## PLANNING COMMISSION MEETING

Application 2016-04-CUP-DR

## PLANNING COMMISSION STAFF REPORT EXHIBIT "A" FINDINGS OF FACT

**Application Number:** 2016-04-CUP-DR  
**Application Name:** Duplexes Lot 36, 37, 38 Raze Meadows Subdivision  
**Staff Contact:** Erika Palmer, Senior Planner (503) 674-6242  
**Date of Report:** April 19, 2016  
**Public Hearing Date:** April 26, 2016

**Fairview P2016-04**

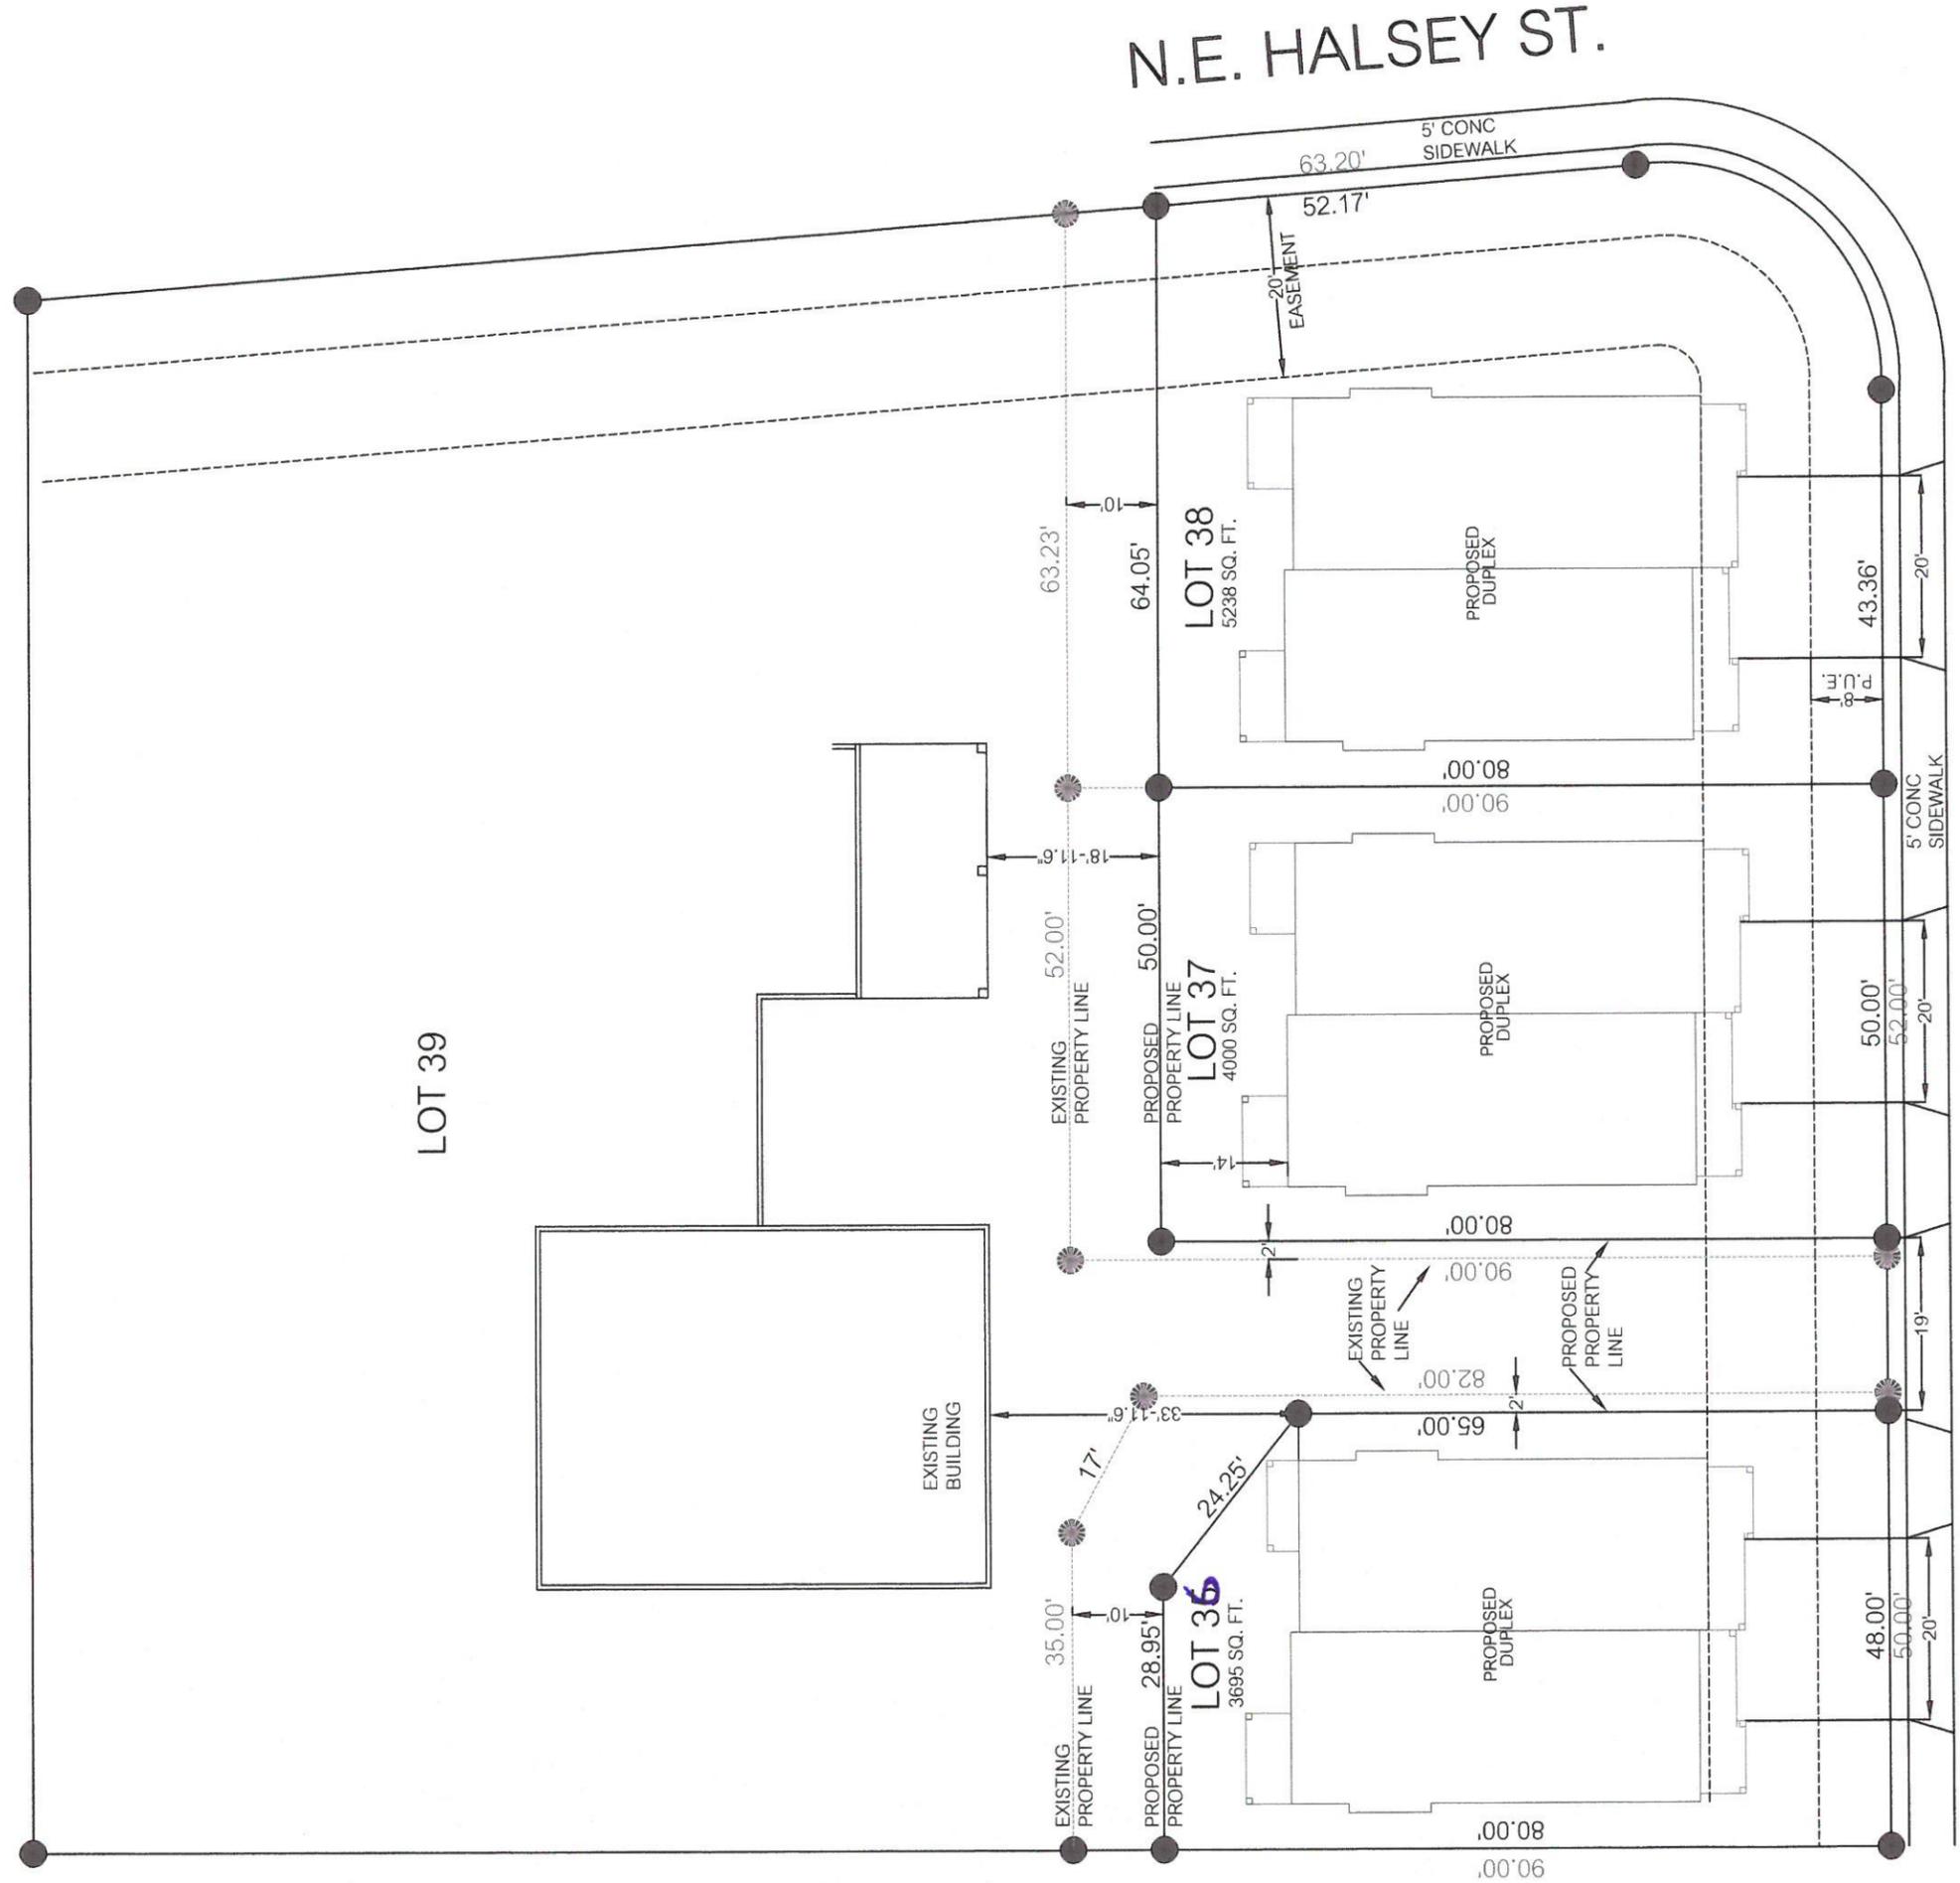
6. Access roads shall support an imposed load of at least 75,000 lbs. Provide an engineer’s letter stating that requirement was met during subdivision final. **OFC 503 & APP D-102.1**

7. The location of the fire hydrants are not indicated on the plans. A fire hydrant must be within 600 feet of the furthest point around the furthest home. This is measured as the fire hose lays on the ground. Fire Hydrants will be required to have Storz quick connection adapters installed. I can email you a copy. **OFC 507.5**
